**City of Biddeford
Historic Preservation Commission**

RE: **Item 4.1: 2025.37 HPC Review** Archetype Architects to revise the design of a previously approved project at 6 and 14 Main Street, Tax Map 71, Lot 10/1 and Tax Map 71 Lot 10/4, respectively, in the MSRD-3 Zone.

Modification Request

Project:
BUILDINGS 19 & 20
PEPPERELL, BIDDEFORD, ME

A3.11

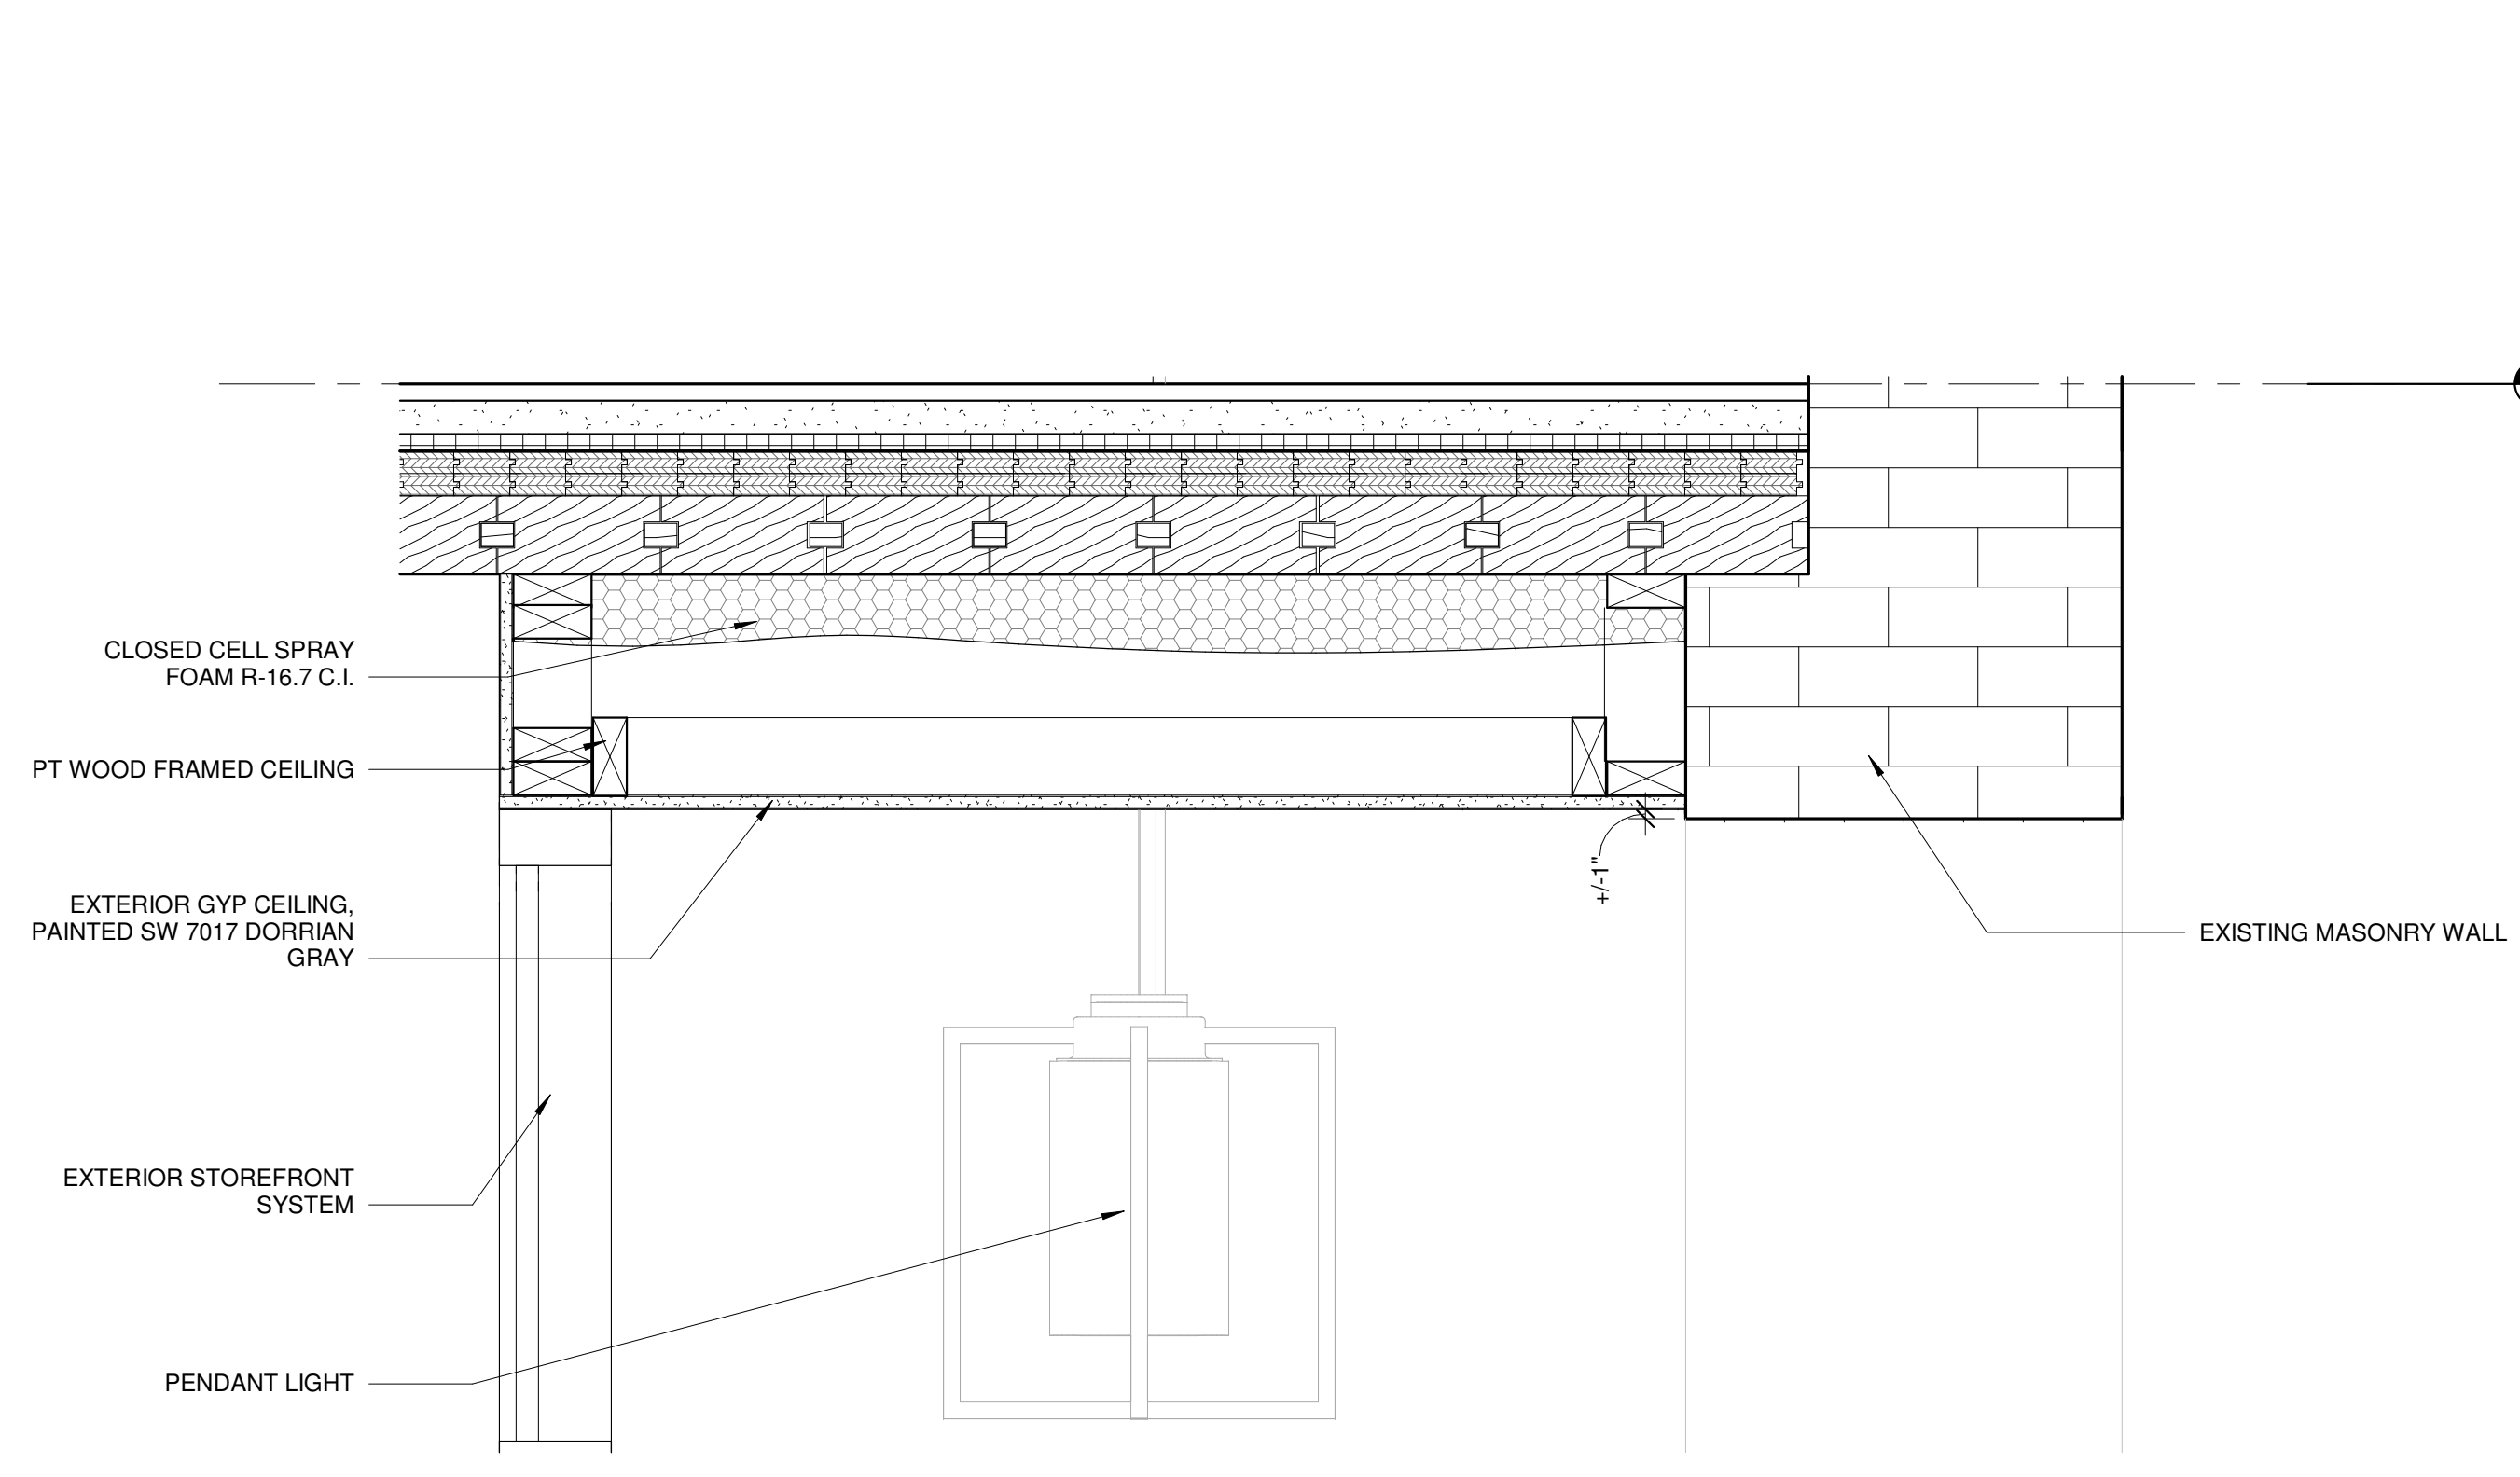
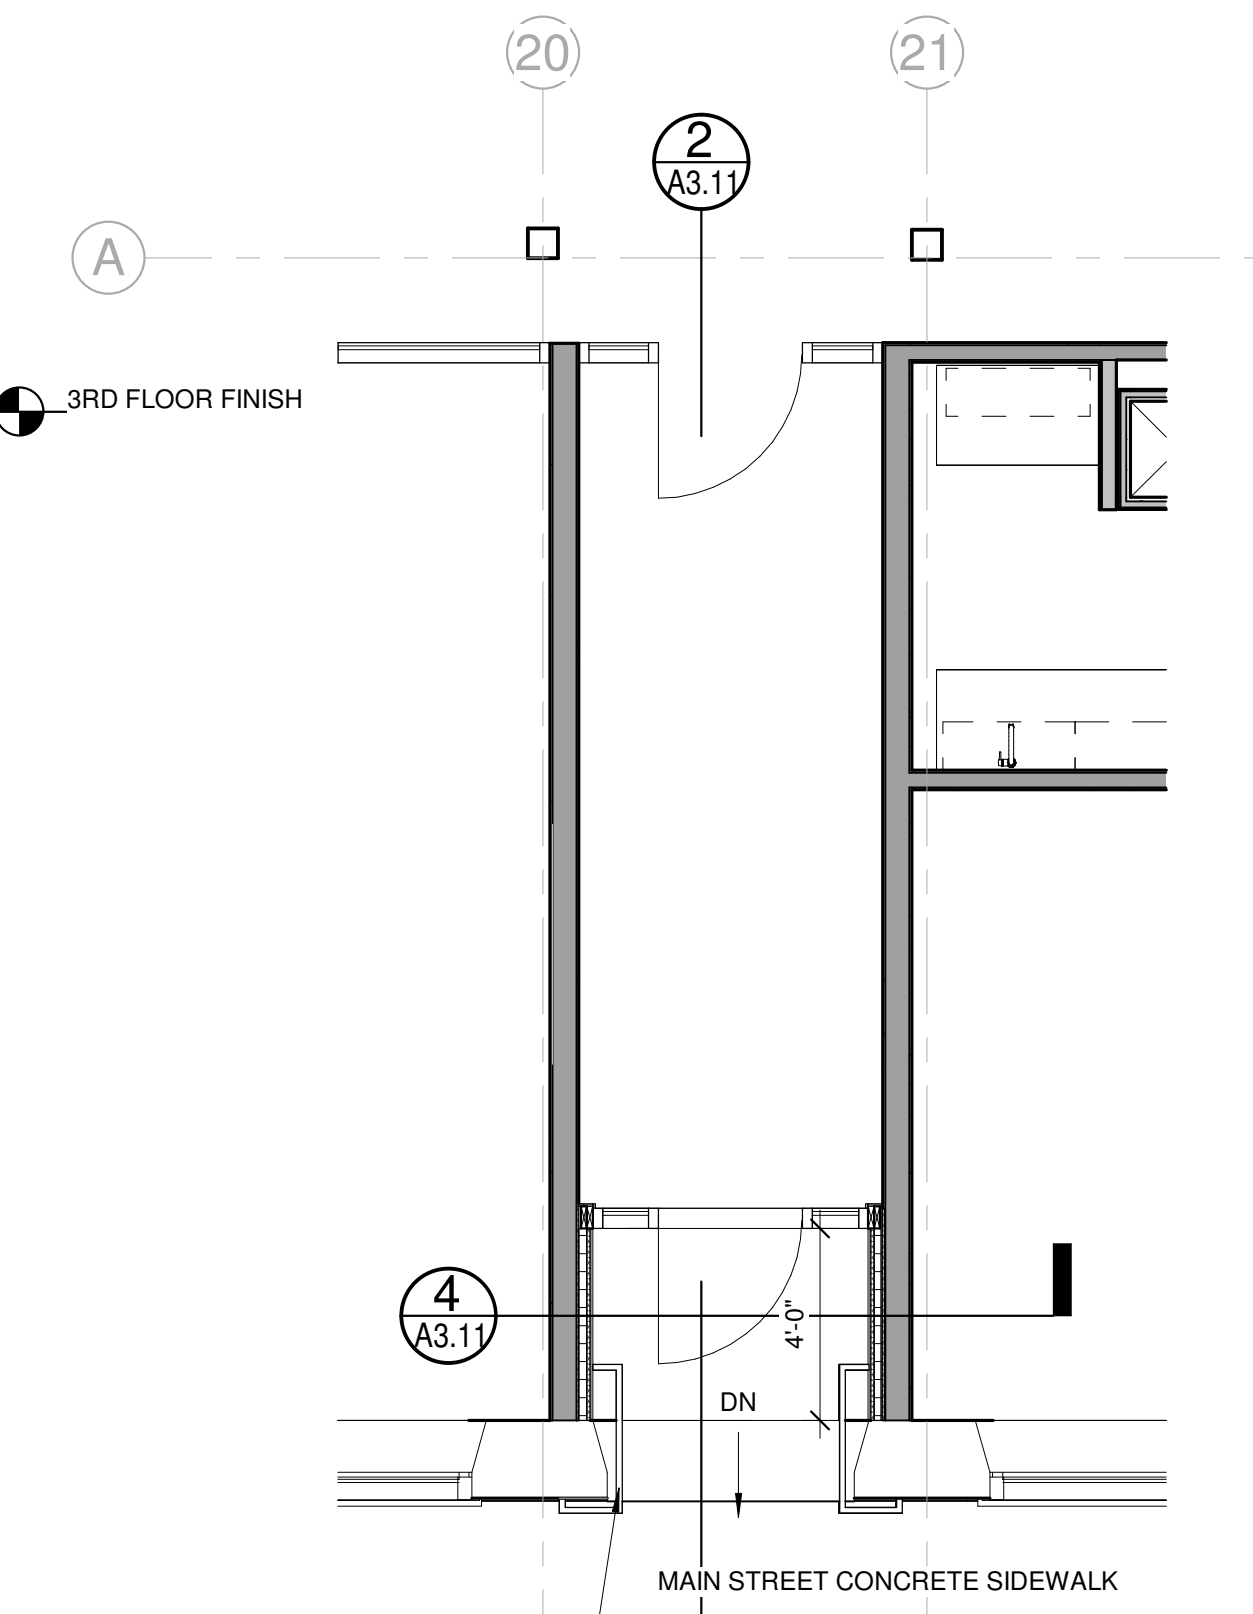
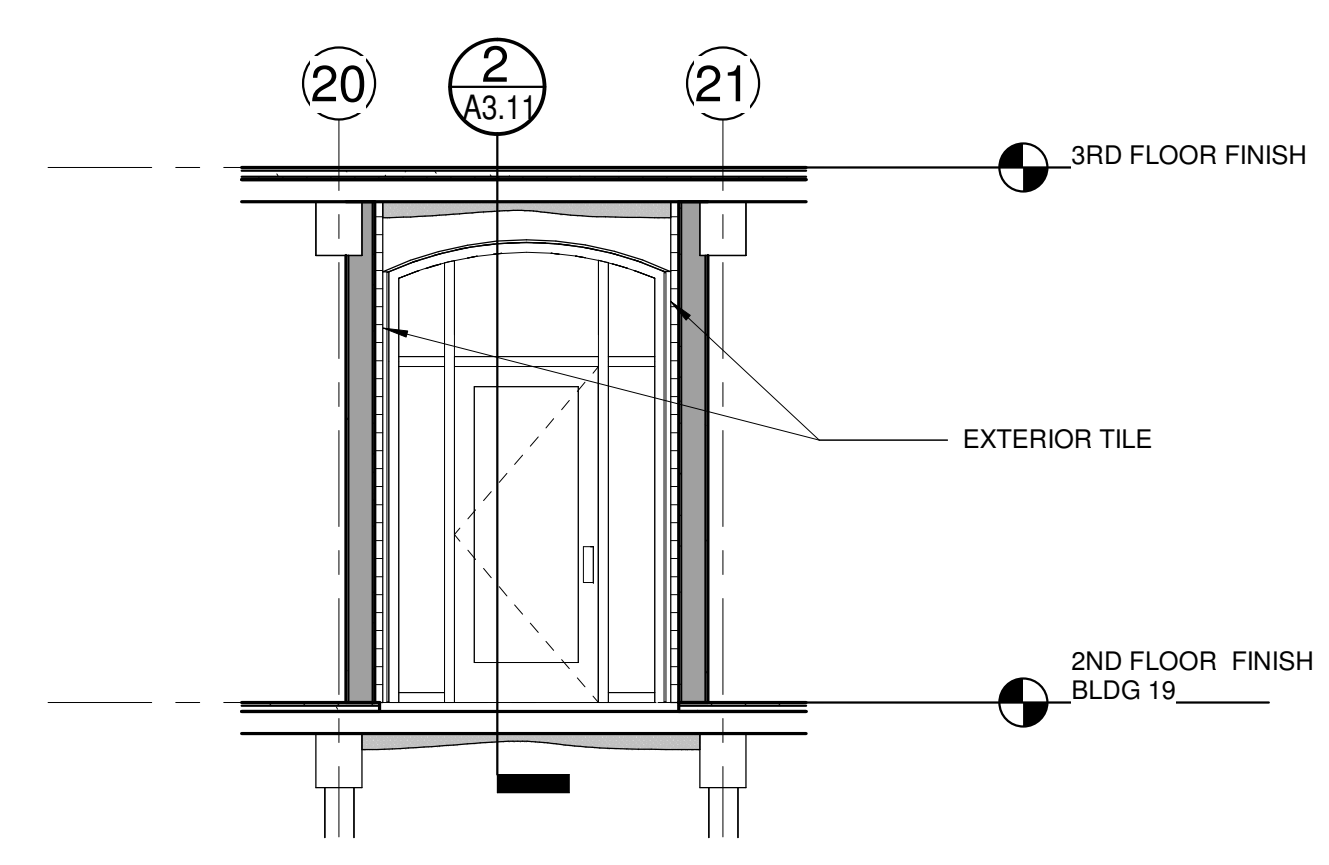
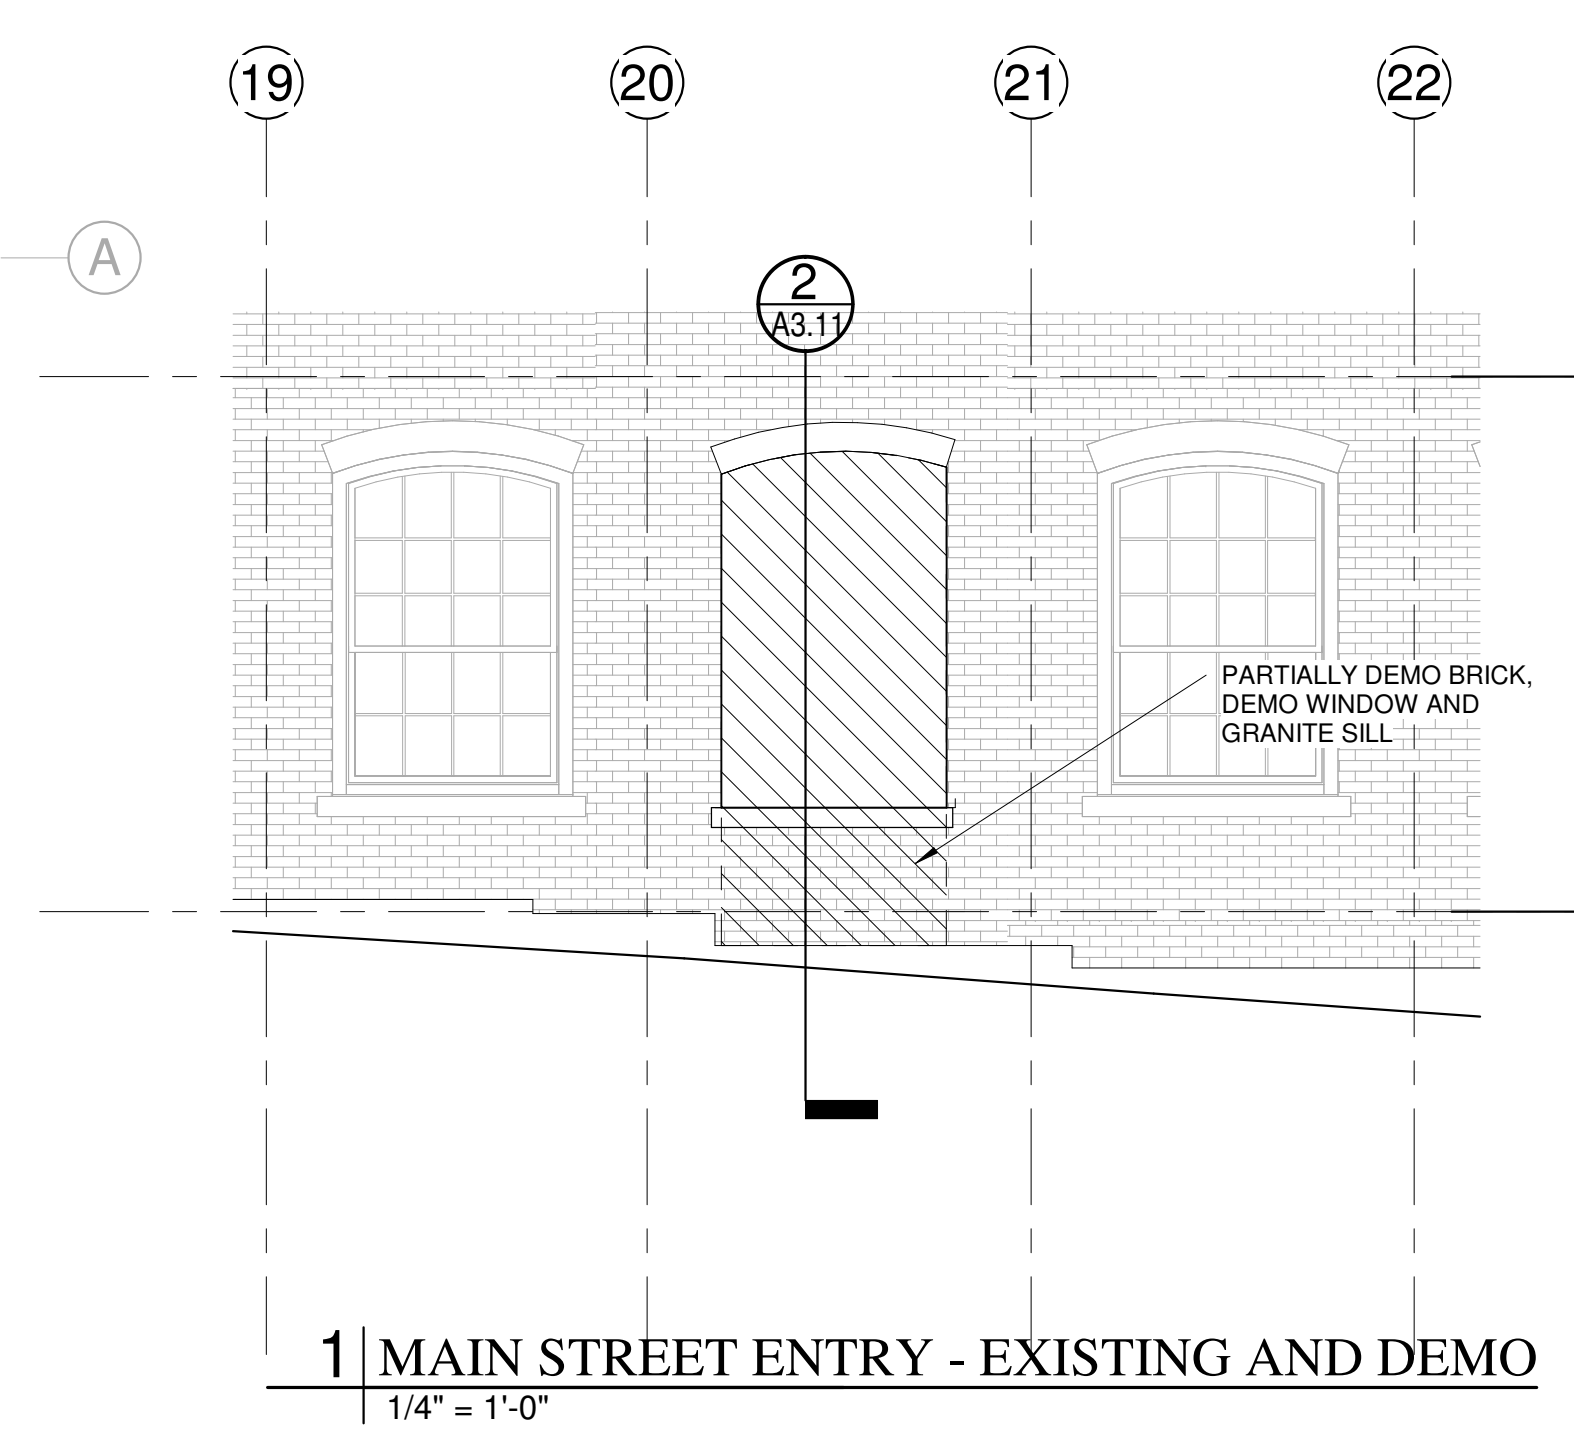
We propose adding a new entry of Main Street located in building 19 on the 2nd floor between column lines 20 and 21. The entry door will be recessed and will swing outward into a small entryway. There will be two risers and handrails. An exterior pendant light fixture will be installed in the recessed entryway. See Dwg A3.11 dated 11/14/2025.
